The Effect of Temperature Variations on the Camber of Precast, Prestressed Concrete Girders

The research presented in "The Effect of Temperature Variations on the Camber of Precast, Prestressed Concrete Girders" by Hang Nguyen, John Stanton, Marc Eberhard, and David Chapman in the September–October 2015 issue of *PCI Journal* is timely and useful. This article is aimed at estimating thermal camber for precast, prestressed concrete beams based on ambient temperature.

Authors' response

Figure 1. Variation of measured thermal camber, ambient air temperature, and the girder temperature difference between the top and bottom flange surfaces for a BTE145 girder. Note: ΔT = temperature difference over the height of the girder. 1 in. = 25.4 mm; °C = (°F – 32)/1.8.

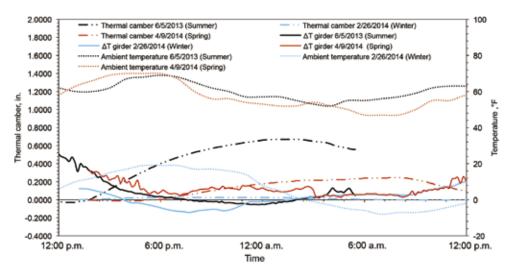
0.74 in. (18.8 mm) whereas the corresponding value in winter is almost zero, though the difference between the maximum and minimum ambient temperatures is comparable. This highlights the impact of solar radiation on the girder temperature. Capturing this phenomenon using A_0 and A_1 and the ambient temperature as approached in the paper may not produce accurate camber in different seasons. This aspect is further explained in Fig. 1 using a standard Iowa Department of Transportation prestressed BTE145 girder with a length of 145 ft (44.2 m) and height of 63 in. (1600 mm).

Figure 1 shows thermal camber measured for a BTE145 girder over several hours in three different seasons and the girder temperature difference between the top and bottom flange surfaces. Also shown in this figure is the ambient temperature for the three cases. A summary of the maximum camber values is presented in Table 1 with those predicted using Eq. (19) with three different A_0 values: 1.31, 0.66, and 1.97. This includes the suggested A_0 as well as $\pm 50\%$ variation on A_0 to account for the scatter reported for this variable in the article by Nguyen et al. Based on the information presented in Fig. 1 and Table 1, the following observations can be made:

With appropriate consideration of time lag, the thermal camber is more reflective of the
girder temperature difference than the ambient temperature difference, and the correlation between the girder temperature difference and the ambient temperature difference
is generally not good. The main parameter that separates these two temperature differ-

ences is solar radiation, and this is most intense in summer and least intense in winter. A more realistic thermal camber estimate may be obtained using the girder temperature difference, which can be estimated using seasonal measurements available for a given region as demonstrated by Honarvar et al.²

The first observation is correct; the models do not account for the effects of solar radiation. However, these effects were not overlooked. Rather, they were disregarded in the interests of keeping the model simple and making it dependent only on input data that are readily available. That decision implies a choice between a relatively accurate model that requires data that may or not be available and one that can provide an approximate prediction with easily available information. Such trade-offs occur in many modeling efforts.

The models could likely be rendered more accurate if different values for the calibration constants A_0 and A_1 were adopted for different seasons (and possibly different regions or states), but such changes would come at the expense of simplicity.

Figure 11. Comparison of measured and calculated thermal camber changes for Washington State girders. Note: 1 in. = 25.4 mm.

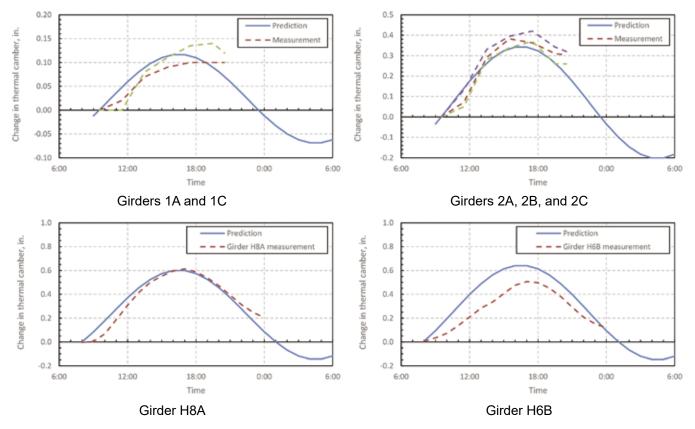
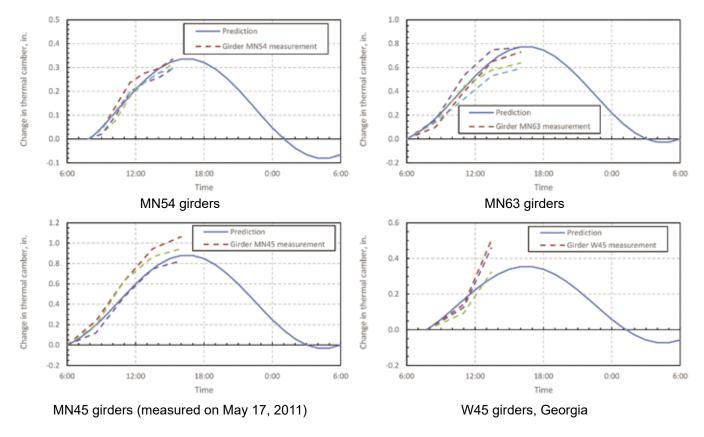
The thermal cambers were also calculated using Eq. (23) and are compared with the measured cambers and those obtained from Eq. (19) for the same BTE145 girder in Table 2. Equation (23), which has the same deficiency in capturing the impact of seasonal effects because it also estimates the thermal camber based on the ambient temperature, provides estimates that are comparable to those obtained from Eq. (19). However, the predicted thermal camber in Fig. 11 and 12 in the paper includes negative values, though Eq. (23) suggests that thermal camber will always be positive since $T_{\max} \geq T_{\min}$. It may be useful to clarify what reference camber was used as the datum to obtain the change in thermal camber reported in these figures.

Last, the discussers seek clarification on the datum for temperature in Fig. 11 and 12 because some values in those figures are negative. The figures show temperature change, rather than absolute temperature, so there is no datum. The values shown are relative to the temperature at the start of reading.

Figure 6. Comparison of calculated and measured thermal cambers. Note: 1 in. = 25.4 mm.

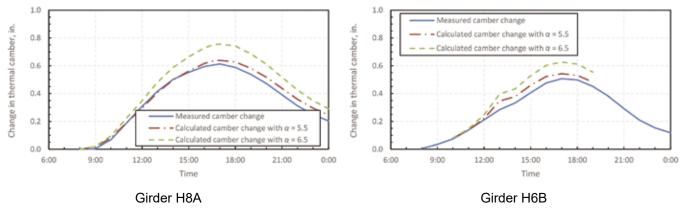
For example, the discussers point out that better correlation with camber can be obtained if the girder temperatures are used. We agree, and we also found good correlation between measured cambers and those predicted from the internal temperatures when the latter were available. Figure 6 in the paper shows an example. However, the question arises of what to do if the internal girder temperatures are not available, and that is what the approximate models are intended to address. It is not clear how the discussers obtain girder temperatures from "seasonal measurements for a given region as demonstrated by Honarvar et al.2" because that paper was not available at the time of publication. If there is an easy way of developing accurate thermal profiles for a girder from meteorological information, we would welcome its use because it would certainly improve the models' predictions.
